7.2.2 Low-voltage terminals (Present)

7.2.3 Low-voltage terminals (Proposed)

Figure 2—Low-voltage terminal stud details

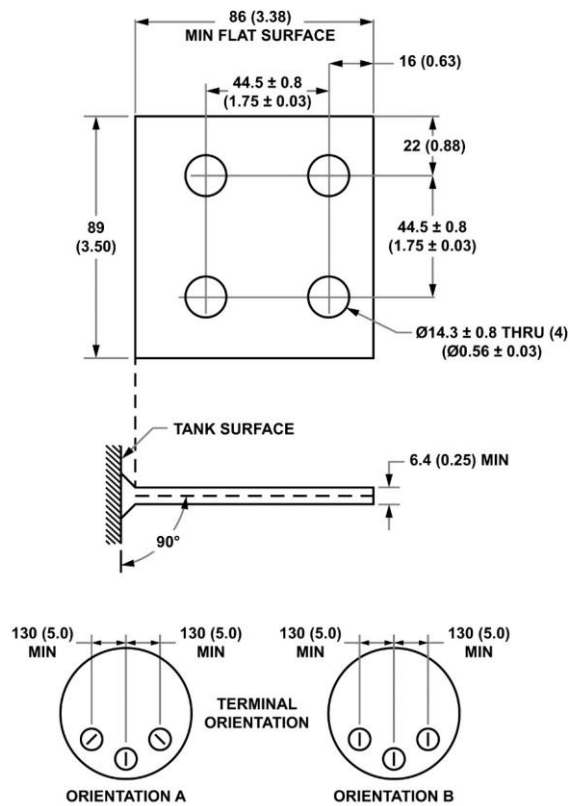
Commented [AT8]: Combined footnotes a and b. Added minimum useable thread

Commented [AT9]: Added bibliography reference.

Commented [AT10]: Tolerance is not need when dimension is specified as a minimum

Low-voltage terminal stud size ^a		Showing for reference only			
Thread size	Minimum L	C57.19.02	C57.12.38	C57.12.24	C57.12.34
0.625–11 UNC–2A	31.75 (1.25)	32 (1.25)	31.75 (1.25)	32 (1.25)	32 (1.25)
1.000–14 UNS–2A	44.45 (1.75)	44 (1.75)	44.45 (1.75)	44 (1.75)	44 (1.75)
1.250–12 UNF–2A	63.5 (2.5)	67 (2.625)	63.5 (2.5)	67 (2.62)	67 (2.625)

^a Dimension “L” is shown in millimeters (inches) and shall be the minimum useable thread length prior to any jam nuts, ground straps, or secondary connectors. Longer stud lengths may be required for user-supplied secondary connectors. Larger thread size or length, or both, may be required if materials other than copper are used. Stud thread sizes are standard trade sizes [B2] and are shown in inches only.

Figure 3—Spade terminals

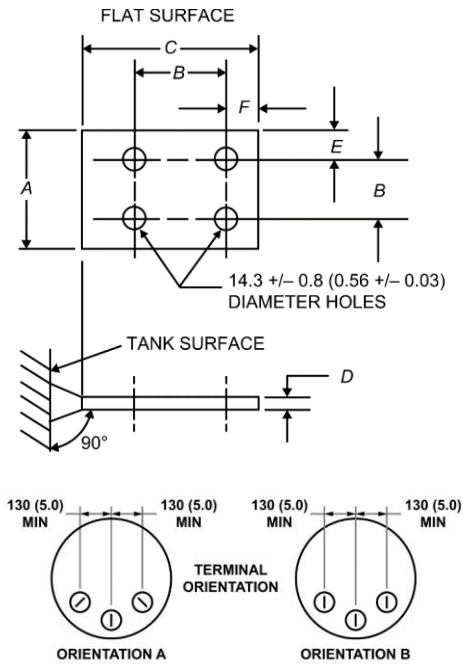
Commented [AT11]: H-spade same as other stds.
Change figure title to H-spade terminal?
Add J spade? 4" wide X 0.25" thick

Commented [AT12]: Spade dimensions match existing 12.23, 12.24 and 19.02

Commented [AT13]: H-spade same as other stds. Add J spade? 4” wide X 0.25” thick? 0.375” thick?

Spade Size	A	B	C	D	E	F
H-Spade	89 (3.50)	44.5 \pm 0.8 (1.75 \pm 0.03)	86 (3.375)	6.4 (0.25)	22 (0.875)	16 (0.625)
J-Spade	102 (4.00)	44.5 \pm 0.8 (1.75 \pm 0.03)	114.3 (4.50)	6.4 (0.25)	29 (1.125)	22.4 (0.875)

^a Dimensions are minimums unless a tolerance is specified
 NOTE 1 – Dimensions are shown in millimeters (inches)
 NOTE 2 – Spade thickness “D” may need to be larger to provided adequate ampacity.
 NOTE 3 – Corners and edges may be rounded.
